**Project Name: UNIVERSITY OF CALIFORNIA, MERCED
CLASSROOM AND OFFICE BUILDING 1 RENOVATION**

Project No.: 908078

ADDENDUM NO. 1
to the
CONTRACT DOCUMENTS
March 18, 2020

Sheet Number: ID0.3.02

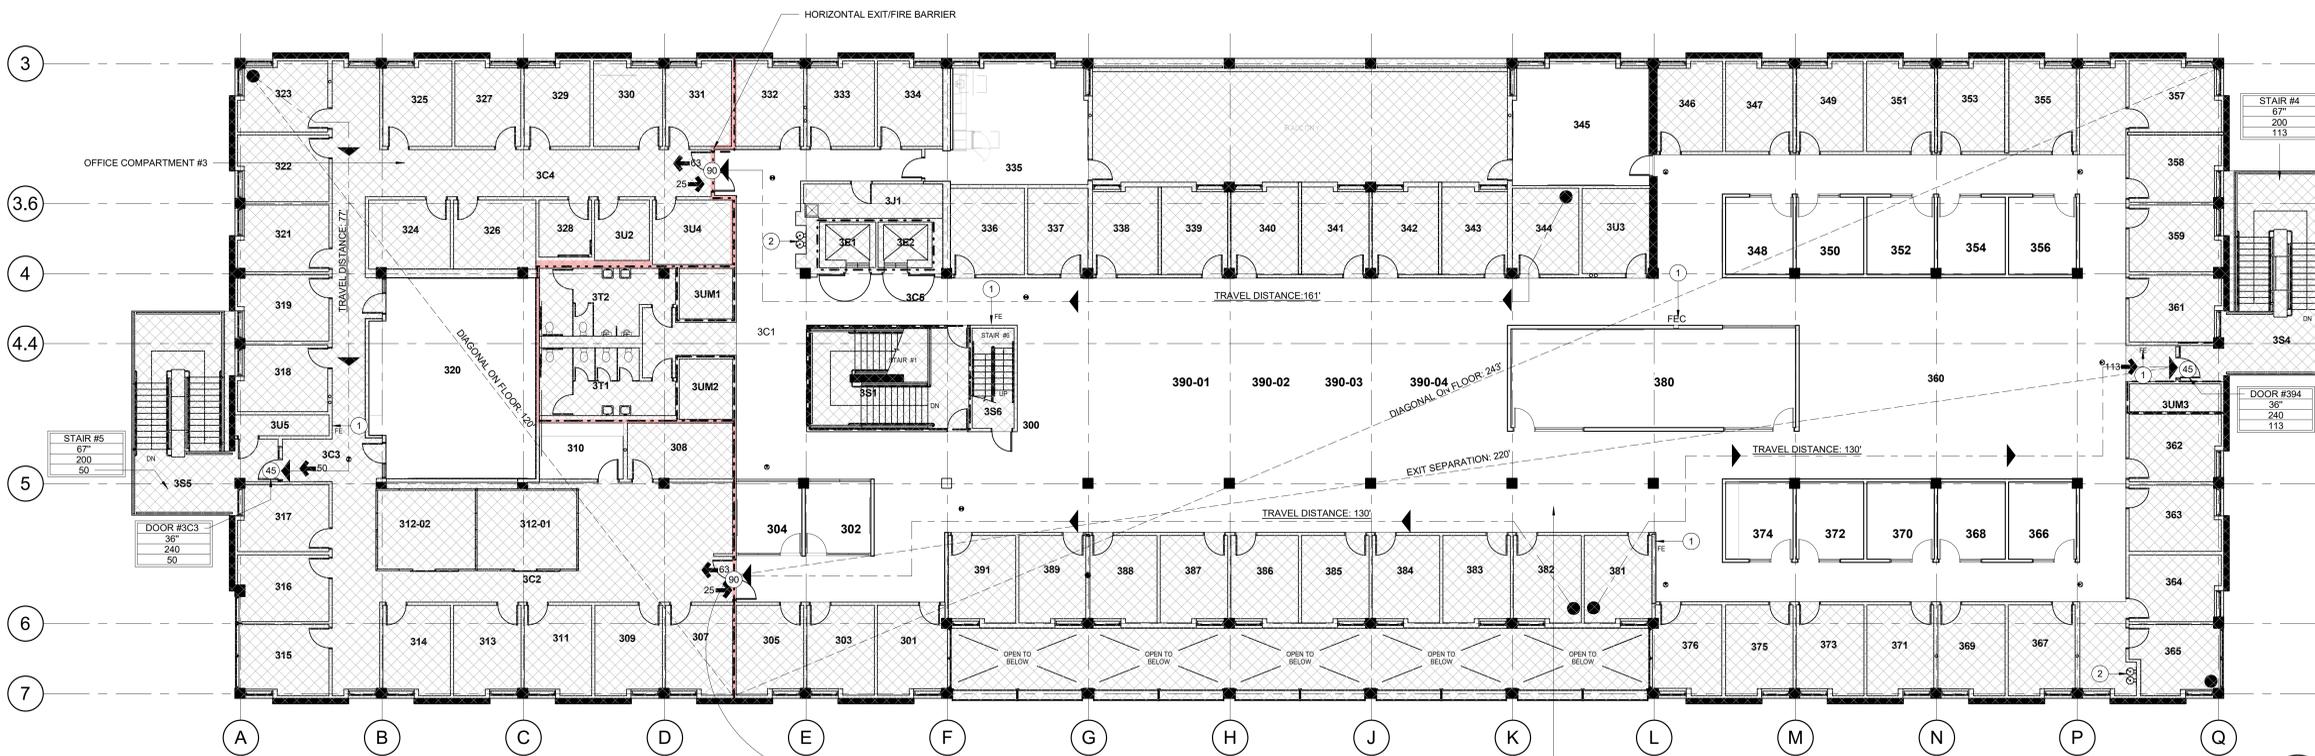
ID0.00	COVER SHEET	1. Added ID8.09, E1.02B and E3.02B sheets on Electrical set drawings
ID0.3.02	2ND FLOOR LIFE SAFETY PLAN (REFERENCE ONLY)	1. Revised Occupancy of corridors and compartment areas. Removed S door and added a double flush
ID0.3.03	3RD FLOOR LIFE SAFETY PLAN (REFERENCE ONLY)	1. Revised Occupancy of corridors and room. No additional fixture needed
ID1.01	1ST FLOOR DEMOLITION PLAN	Added note for repair/replacement of floor boxes located on stage of room 102
ID1.03	2ND FLOOR DEMOLITION PLAN	1. Room 241 remaining wall 2. Room 241 changed swing of door 3. Demo S door 4. Demo wall on room 261 5. Remain entry wall and door of room 261
ID1.04	2ND FLOOR RCP DEMOLITION PLAN	1. Remain room 241 RCP 2. Patch and repair ceiling of S door location
ID2.01	1ST FLOOR PARTITION PLAN	1. Removed drinking fountain from scope 2. Added note for repair/replacement of floor boxes located on stage of room 102

Sheet Number: **ID2.02**

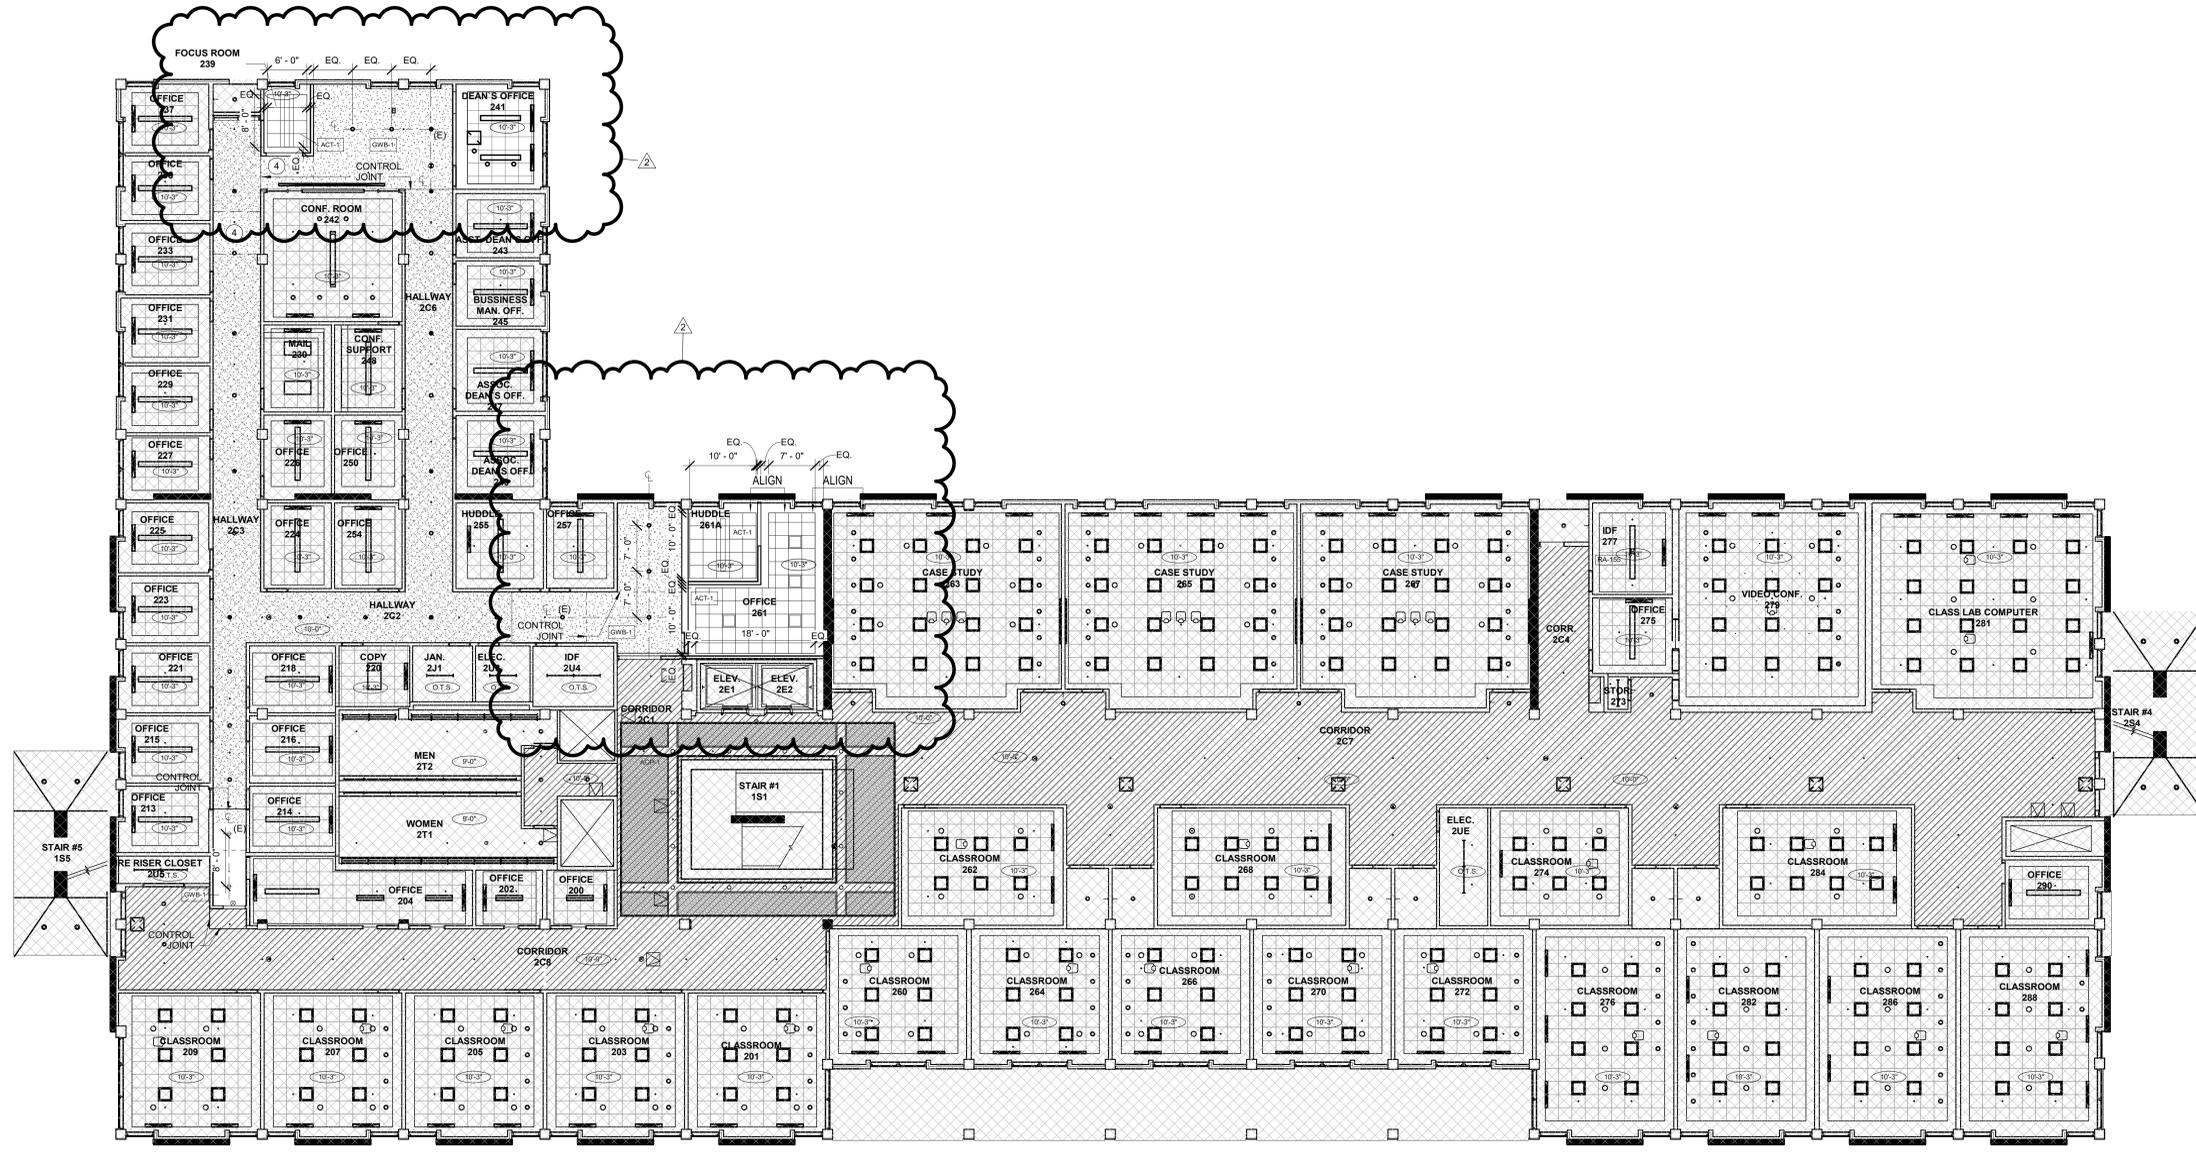
ID2.02	2ND FLOOR PARTITION PLAN	1. Changed swing of 2C8A door 2. Added 241 door 3. Added AV on existing wall of room 241 4. Created a 261A room 5. Added AV on existing wall of room 261A 6. Added elevation of new 261A room 7. Added 2C2 double flush door 8. Added detail for new 2C2 door 9. Added A2CD rated wall 10. Added S2KK rated wall 11. 259 became an open office 12. 239 changed name to focus room
ID3.02	2ND FLOOR REFLECTED CEILING PLAN	1. Modified RCP of 259,261 and 261A room 2. Remain room 241 RCP
ID5.02	2ND FLOOR FINISH PLAN	1. Remain room 241 finishes 2. Added finishes on 259,262 and 261A room

Sheet Number: ID7.02

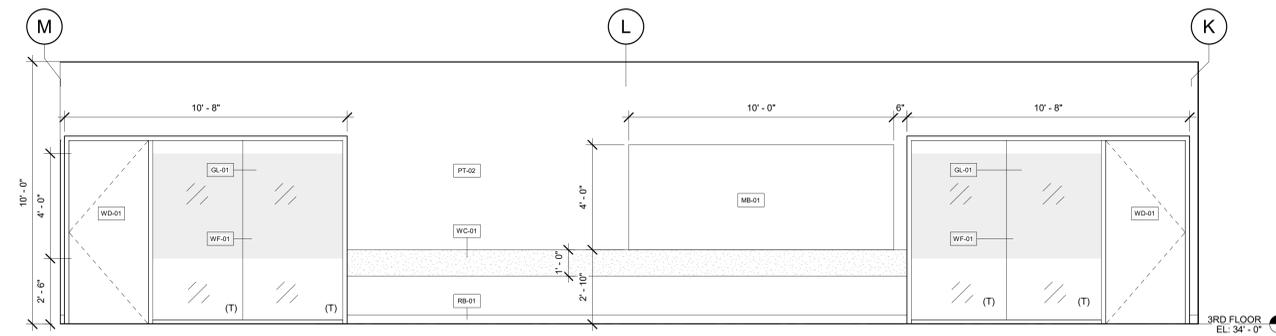
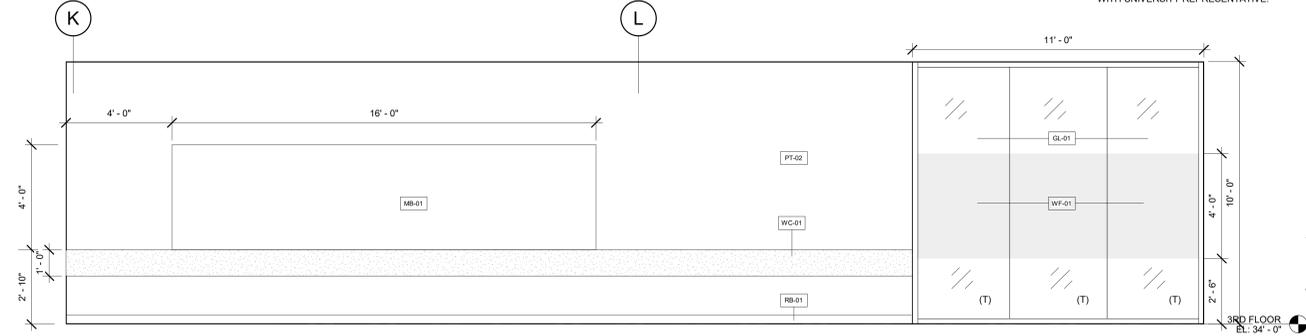
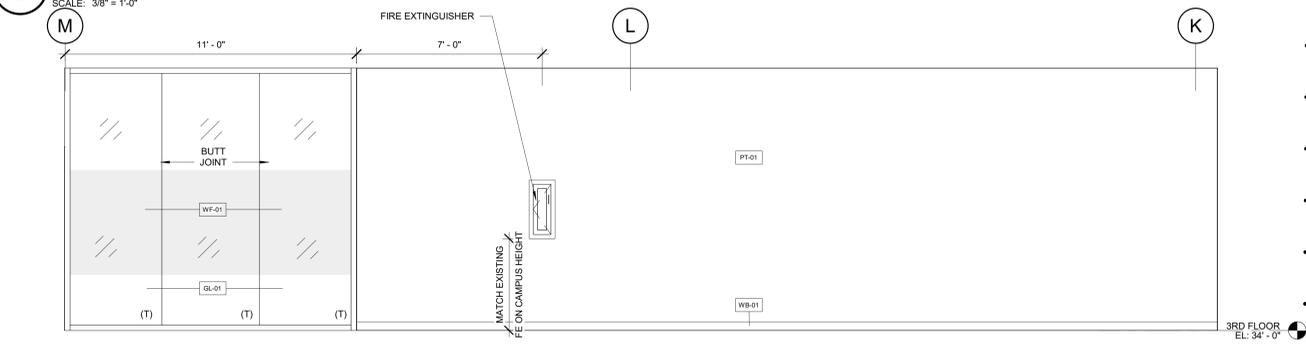
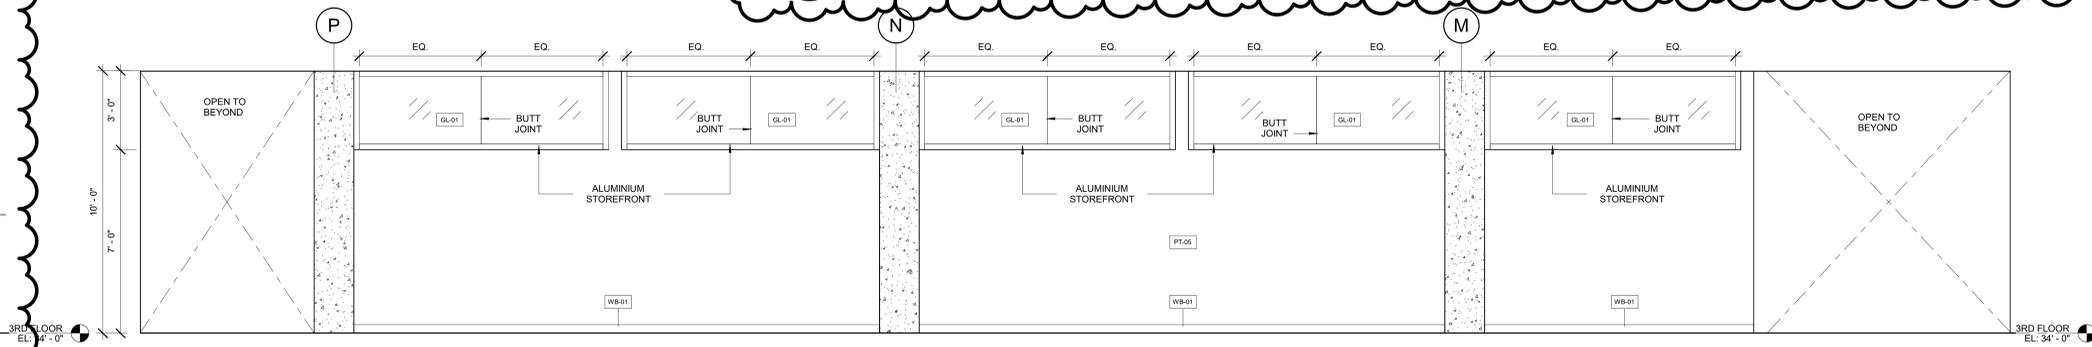
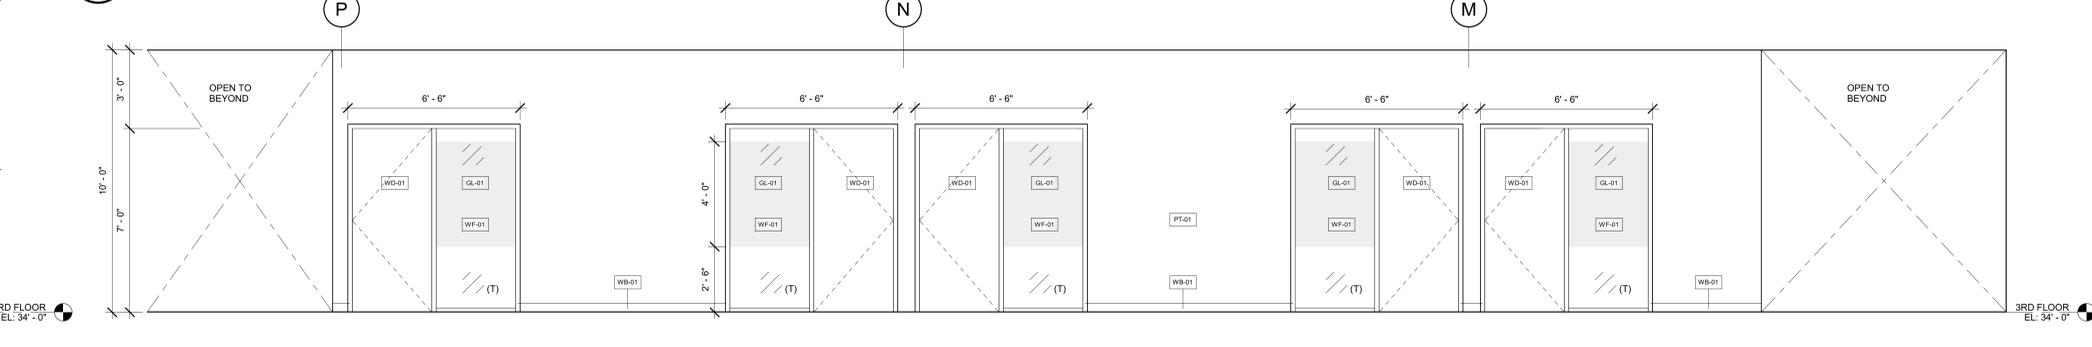
- 10. Q. Reference: 13/ID7.02, Room 345. Please confirm if the aluminum storefront framed is fabricated out of 450 framing.
 - A. Room 345 doesn't have new framing, the one showed on the elevation is existing.

- 12. Q. Reference: 1/ID7.02 – Room 302 and 304 are shown as 450 aluminum storefront. These openings are in the same room as door 302 and 304. Are the windows on detail 1 on ID7.02 considered 450 Storefront?

- A. 2 equal floor to ceiling interior storefront for each room. Revised elevation of detail 1 on ID7.02 in this Addendum.
- 13. Q. Reference: ID5.01, ID5.02, ID5.03, 6/ID7.03, 5/ID7.03, 3/ID7.03, 2/ID7.03, 1/ID7.03, 8/ID7.01 – Floor plans indicates rubber base for all areas that will require floor base. On the other hand, the elevation plan for the following rooms call out for Wood Base (WB-01): 380 Office Corridor, 3rd floor corridor, front office corridor, 302/304 South Elevation, and 239. Please confirm if we will need to provide wood base or rubber base for the following locations: 380, Office Corridor 3rd floor corridor, front office corridor, 302/304 South Elevation, and 239.

Sheet Number: **M0.01**

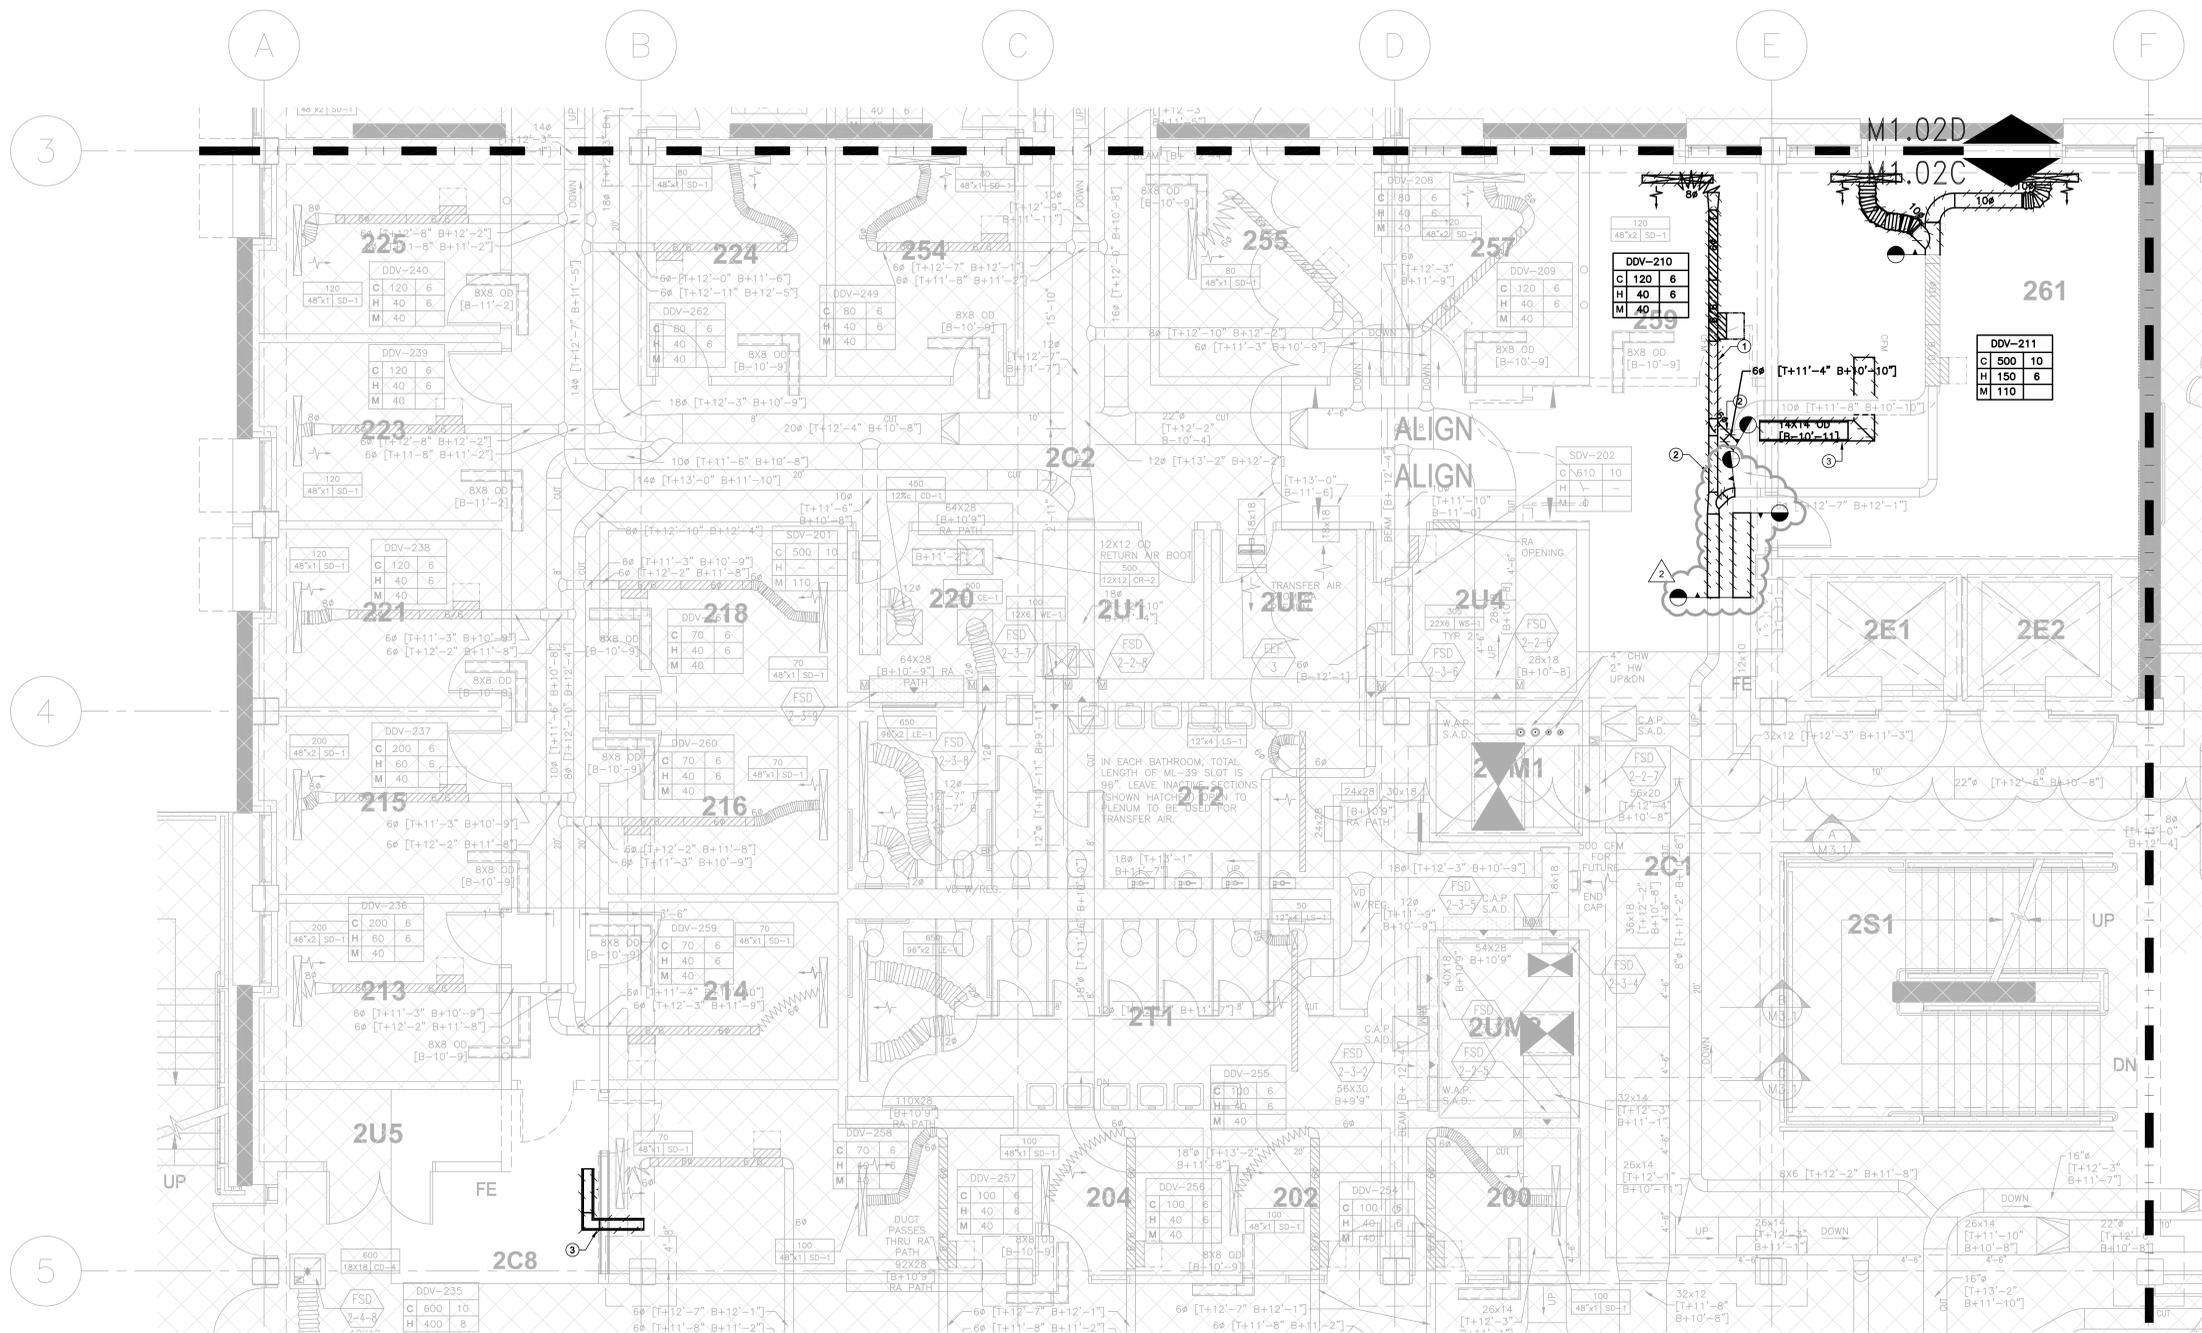
M0.01	SYMBOLS, SCHEDULES, LEGENDS, AND GENERAL NOTES	1. Revised airflow set points of DDV-210, Revised airflow set points of DDV-266 2. Added FSD schedule
M1.02C	SECOND FLOOR MECHANICAL DEMOLITION PLAN	1. Extended demolition of (e) ductwork for new FSD installation
M1.02D	SECOND FLOOR MECHANICAL DEMOLITION PLAN	1. Removed demolition scope of work to fit new
M2.02C	SECOND FLOOR MECHANICAL PLAN	1. Added FSDs and DDV to fit new configuration of offices
